BOARD/COMMISSION RECOMMENDATION

Bicycle Advisory Council

Recommendation Number 20240220-007: Airport Boulevard & the Corridor Program

Image H.

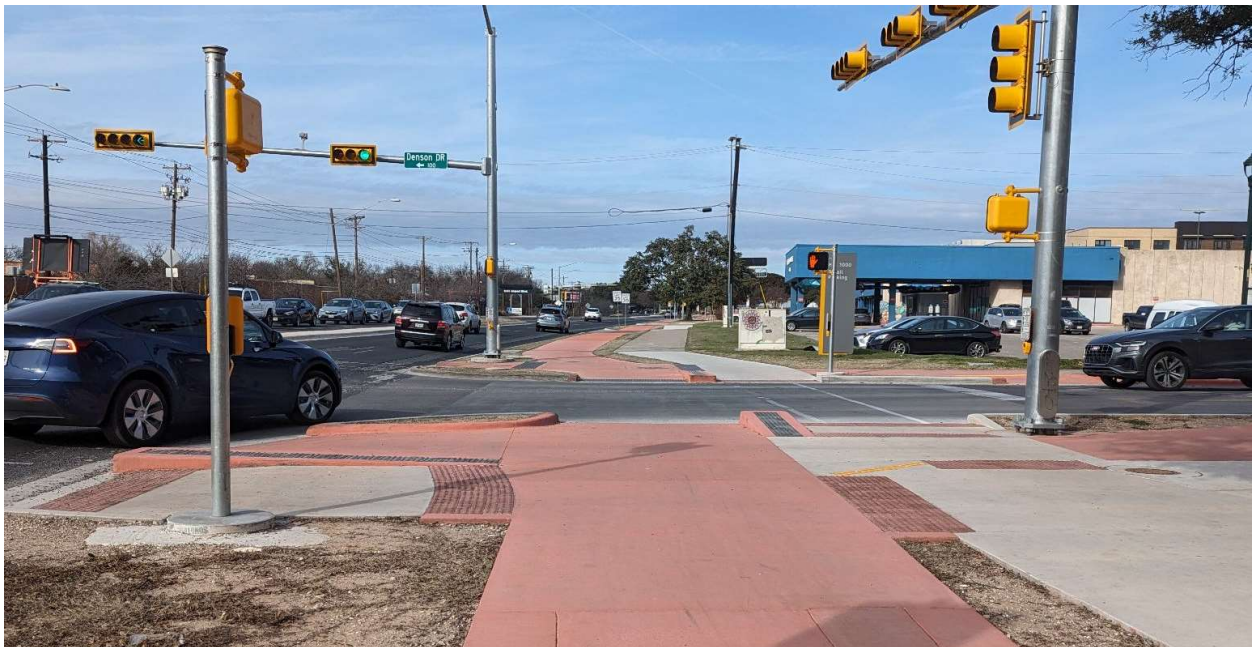
- Guadalupe - Ramps missing on the west side of the street north of Airport
 - Just south of 290, by Middle Fiskville Road, prioritize completing the bicycle path along this section of Airport, as there is no current access to the southern portion of the Corridor without dismounting ([Image H](#))

A missing link on the south end of the corridor pictured here at Middle Fiskeville Rd and E Koenig Ln makes the project inaccessible. Riding further south on Airport requires a dismount.
